October 24, 2017
Medway Planning and Economic Development Board
155 Village Street
Medway, MA 02053

143 Village Street Special Permit and Site Plan – Public Hearing Continuation

Ref: Tetra Tech Comments: 143 Village Street Medway, MA Site Plan Review

**Re: Site Plan Review
143 Village Street
Medway, Massachusetts**

GRADING, UTILITY AND
EROSION CONTROL PLAN

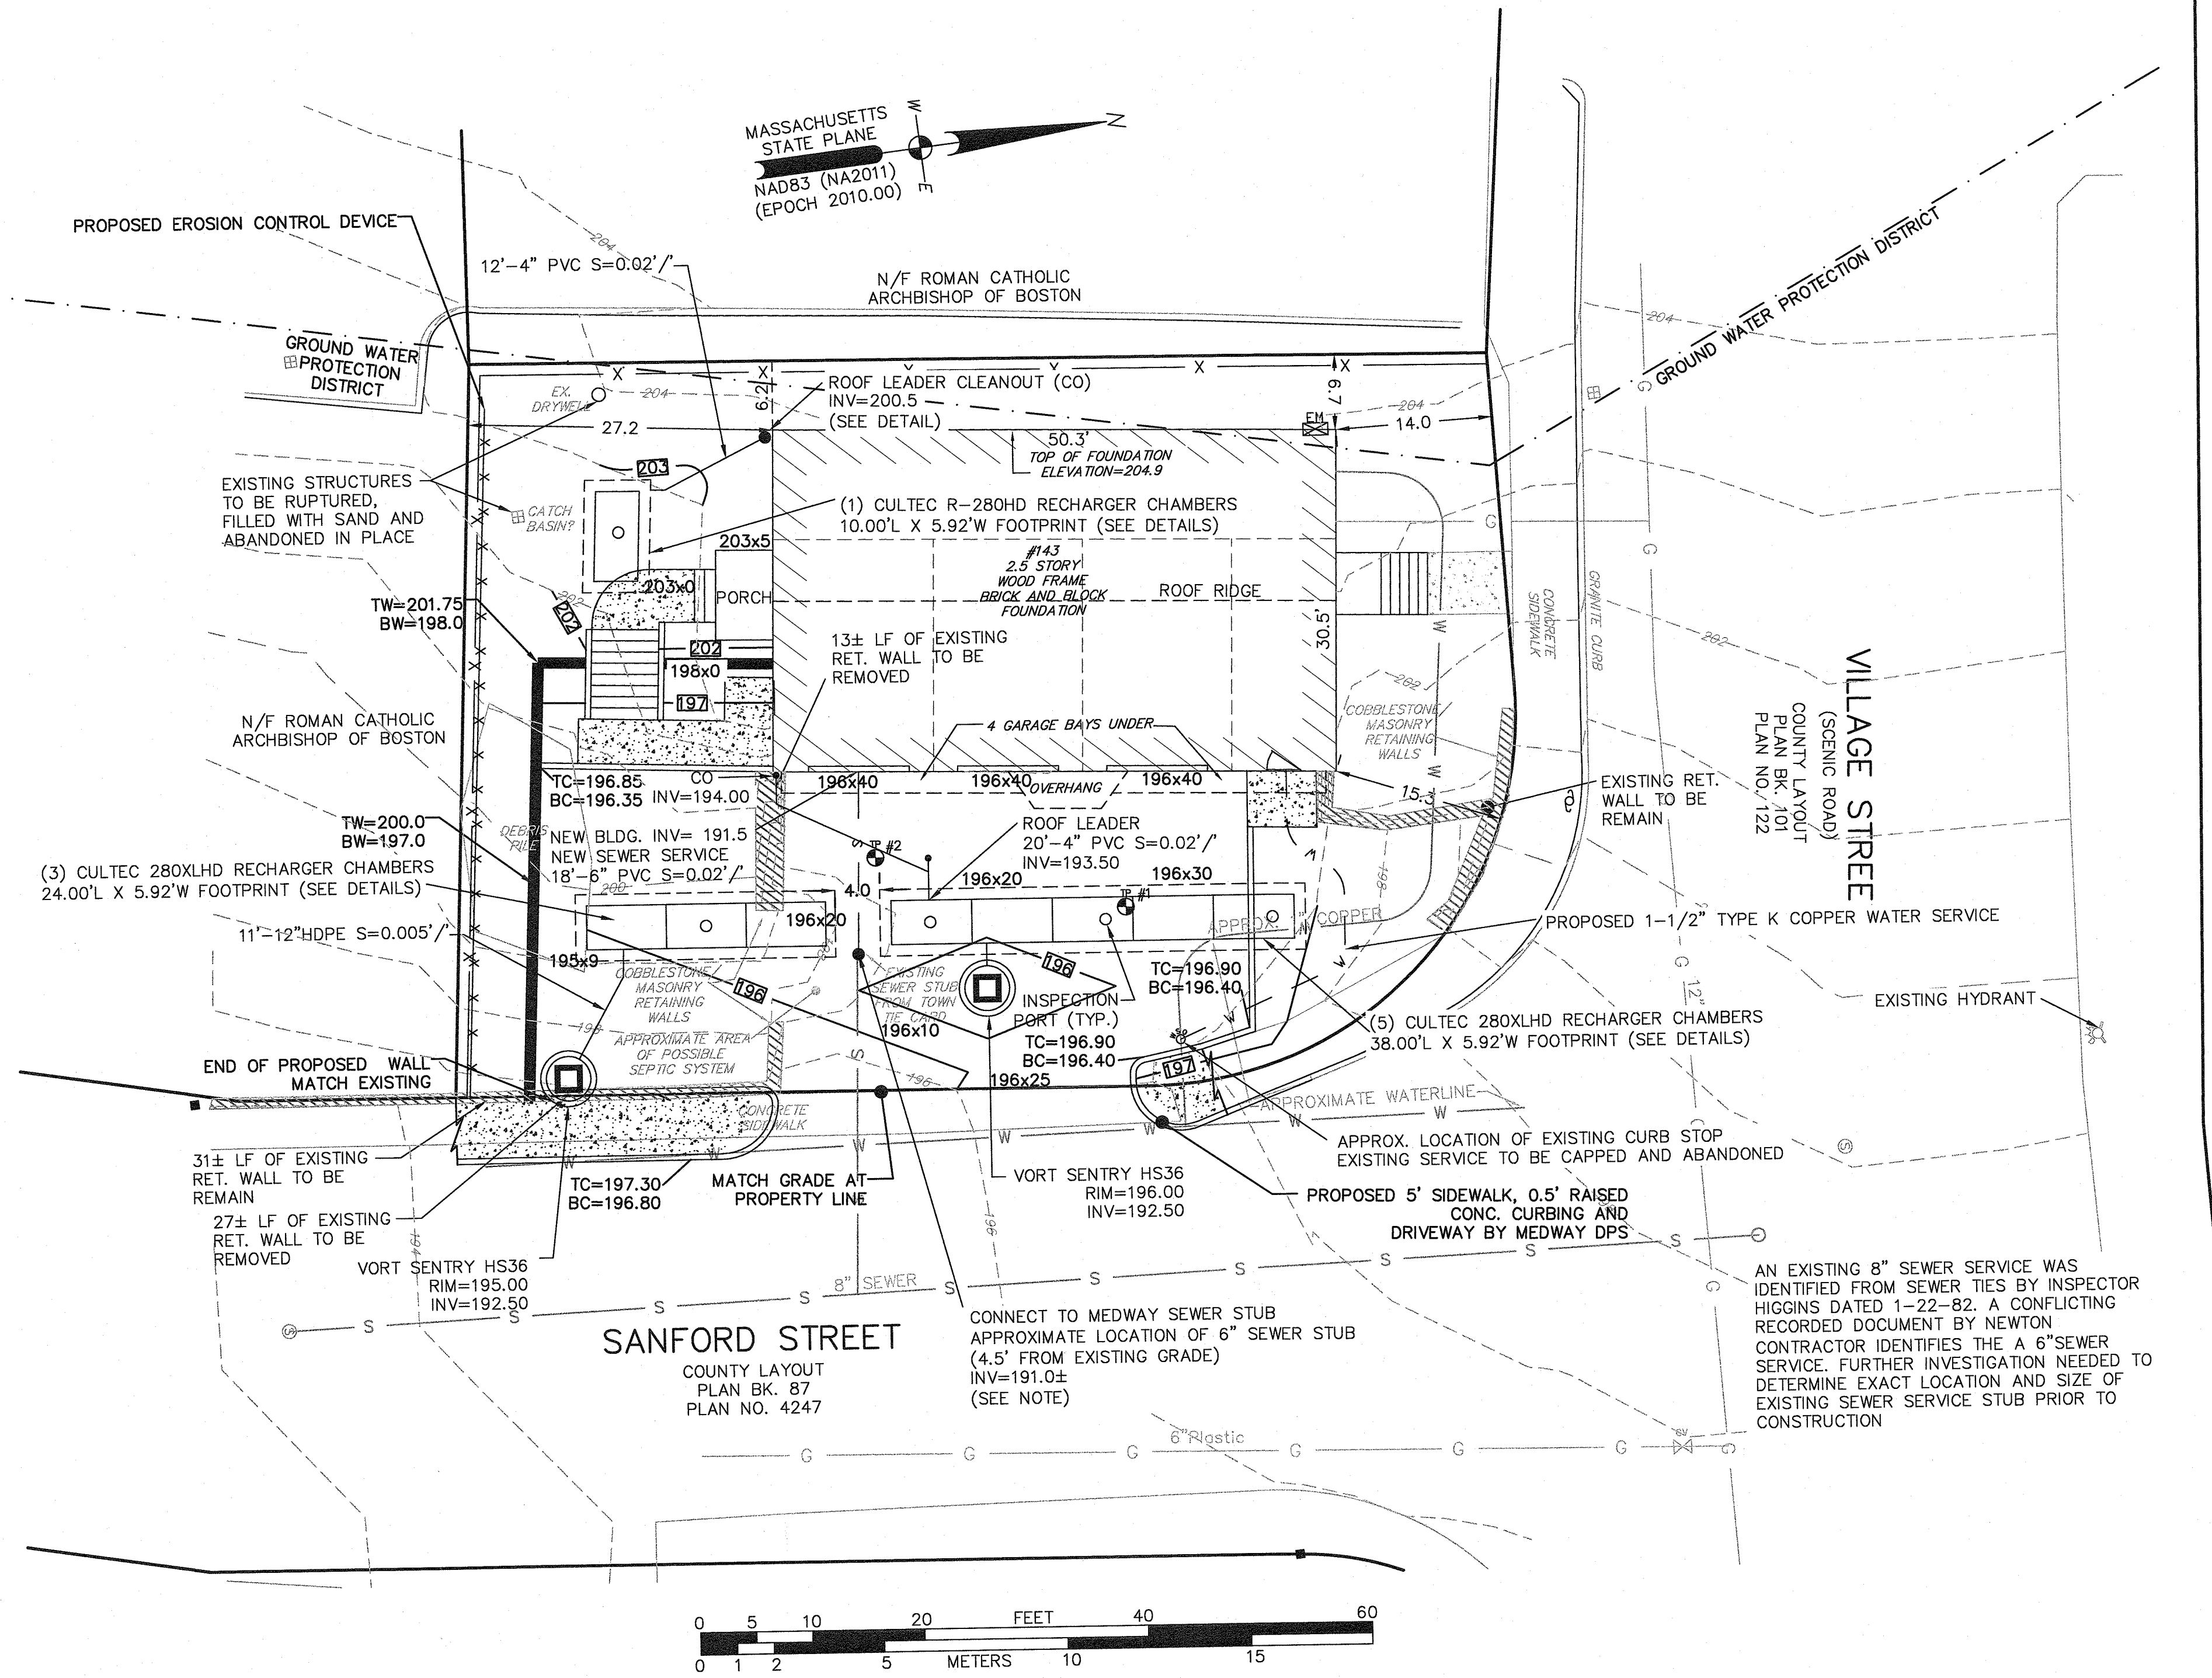
28) *Roof runoff infiltration chamber designed for 2-year storm event. We recommend the applicant provide supporting documentation for 10- and 100-year events to determine potential overflow conditions and to ensure overflow volumes are considered in other stormwater controls.*

- **Revised as requested. See plan entitled “Grading, Utility and Erosion Control” Sheet 4 of 7**

- **G&H agree that the 1” existing water service needs to be upgrade to a 1-1/2" type K copper service to adequately service all units. See revised plan entitled “Grading Utility and Erosion Control Plan” Sheet 4 of 7.**

PROPOSED PHOTOMETRIC
PLAN

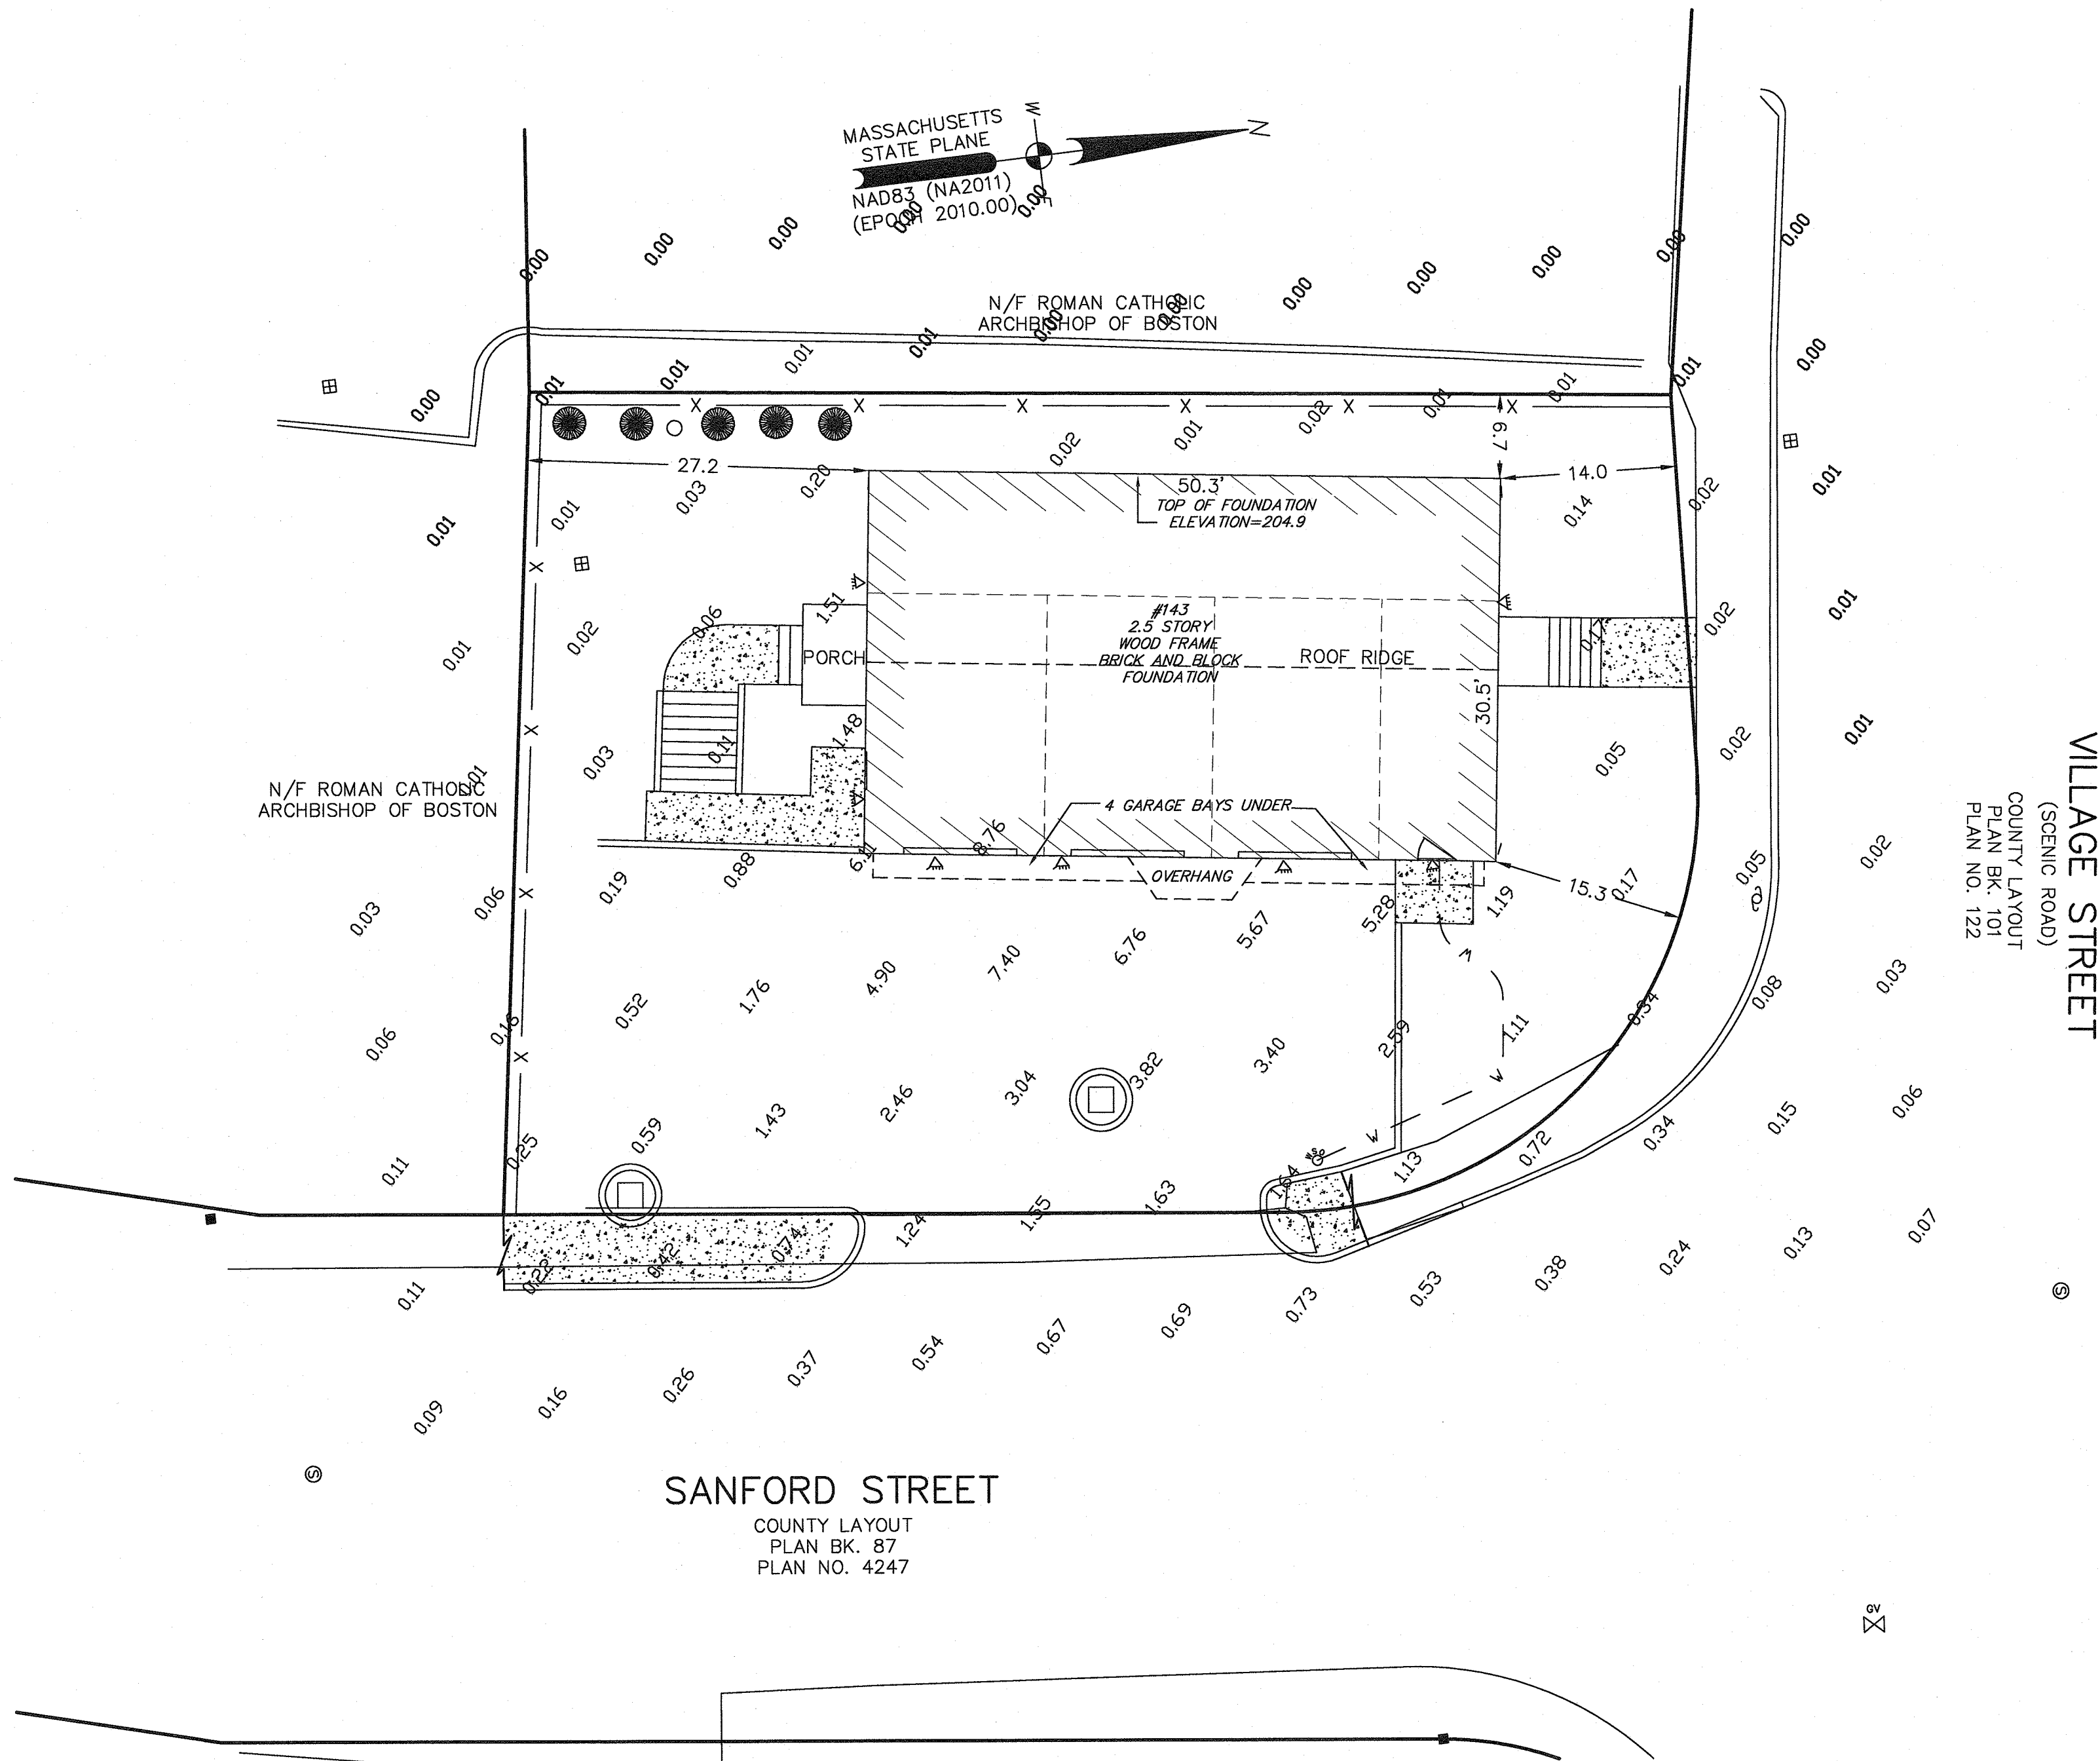
- 17) *The photometric plan provided shows light spill over the property line along all sides of the Project. (Ch. 200 §205-2.O and Ch. 200 §205-8.C)*
- **Revised as requested. See plan entitled “Proposed Photometric” Sheet 5 of 7**

15. A photometric plan for lighting has been provided but it does not comply with Section 7.1.2 (Outdoor Lighting) of the Bylaw since the foot-candle level exceeds .01 for most of the perimeter

- *GHI 10/10/17 Response: Revised as requested. See plan entitled “Proposed Photometric” Sheet 5 of 7.*
 - TT 10/18/17 Update: Light spill remains proposed adjacent to the southeastern corner of the project and along Village/Sanford Street. We recommend the PEDB include this item as a Condition of Approval in the Site Plan Decision for the Project.
